QUESTIONS AND ANSWERS

REGIONAL URBAN WATER AUGMENTATION PROJECT

Date: June 21, 2017
CIP #: RW-0156

Marina Coast Water District

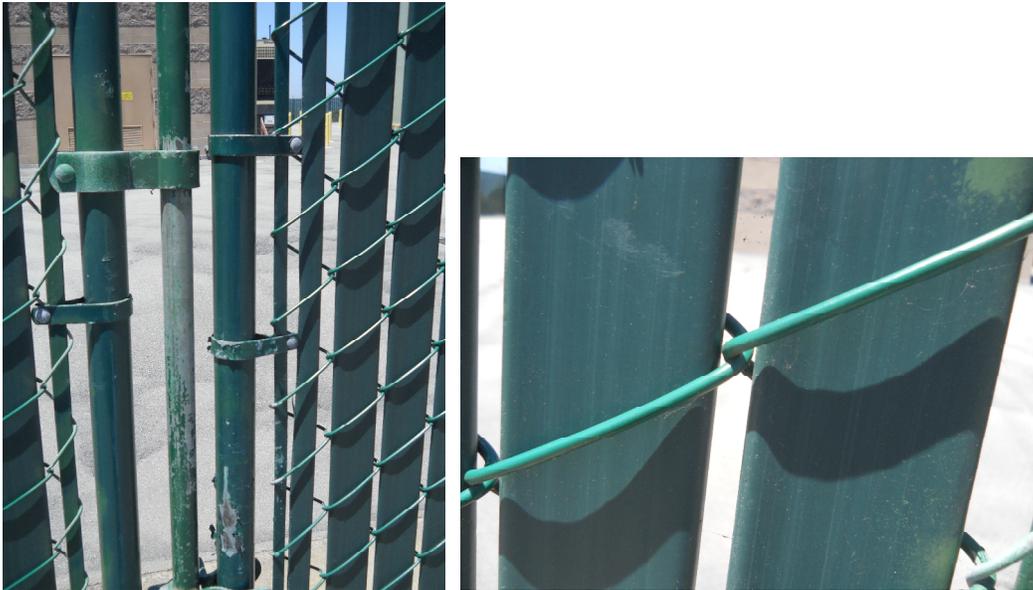
Q50	In the event of finding discrepancies between plans, specifications, and permit conditions, which condition takes precedence?
A50	See the order of precedence in Specification Section 00 73 00.
Q51	Which bid item do the permit fees, added as part of addendum #2 and totaling in excess of \$400k, get assigned to? Why not create an allowance item?
A51	See response to Question 45 for where to include the permit fees in the bid schedule.
Q52	Where can I find a copy of the Marina Standard drawings and specifications? I do not see it on their website...
A52	City of Marina standards are located at: http://www.ci.marina.ca.us/DocumentCenter/Home/View/293
Q53	We looked at the specs for the fence and the wire fabric reads as 6 gauge. Is this the core wire size or is it the finish size of the wire including PVC coating? This spec may cause some difficulties with the wire suppliers. Please clarify the core wire size for the fabric. We hope you can send some pictures of the existing fencing and it gives a clear understanding of what is expected for the chain link fabric.

A53	See Addendum 3. The spec has been updated to include the wire size, PVC coating, and no slats. Pictures are included below.
